NUMBER: 80-7

DATE: 3/17/80

- A. Rewind Starter Repair Kit - Merc 4
- B. Rewind Starter Rope Breakage - Merc 7.5/9.8
- C. New Outboard Service Tools
- D. Timing/Synchronizing/Adjusting - Merc 50

Figure 1. EARLY Style Rewind Starter

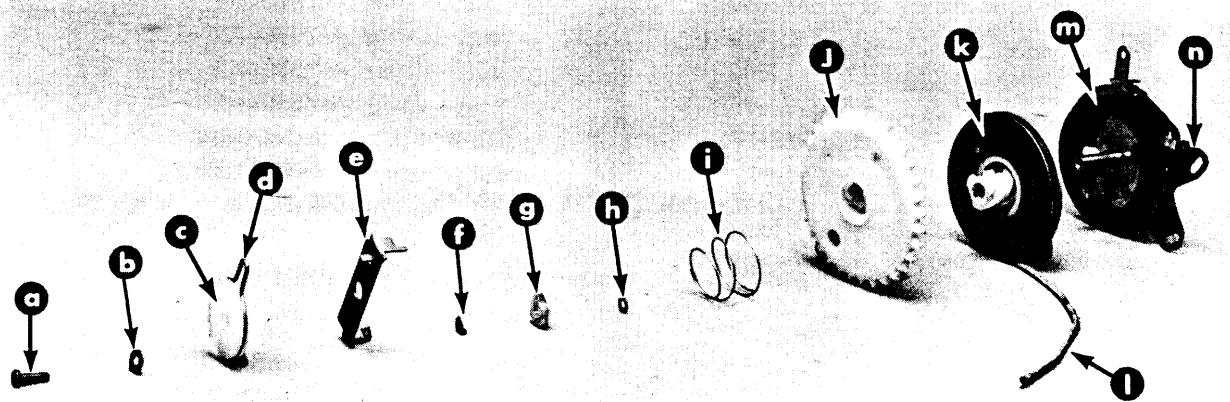
Figure 1 shows the EARLY style rewind starter in assembly sequence. It identifies the components that are to be replaced and/or deleted and those which are to be retained for re-use when rewind starter repair kit (A-75764A2) is installed.

NOTE: RETAIN Items i, k, m and n for Re-use with Rewind Starter Repair Kit (A-75764A2) — DISCARD All Remaining Parts.

To improve operation and reliability of the rewind starter assembly on EARLY Merc 4 (Gnat) motors (serial numbers specified, above), a rewind starter repair kit (A-75764A2) now is available to up-date the rewind assembly to the latest design (1980 style).

Figure 3. Retainer Clip

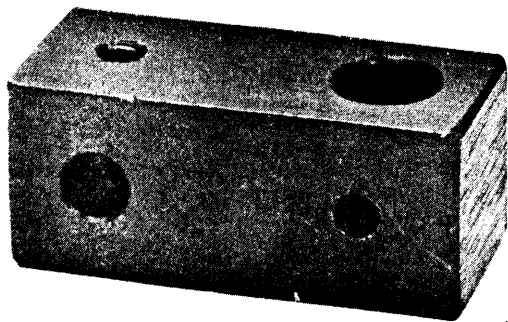
Premature rewind starter rope failures (frayed or broken) on some of the above motors have been traced to sharp edges (caused by chipped plating) inside the aluminum rope guide (in the rewind starter housing).

IMPORTANT: Before installation, the new retainer clip (C-53-72168) MUST BE MODIFIED (as shown in Figure 3) to ensure proper fit and to secure the synthane rope guide in the rewind starter housing.

Cut or grind 1/8"(3.2mm) off each tip of the retainer clip --- then "round-off" inside edge of each tip to provide a smooth "lead-in" angle.
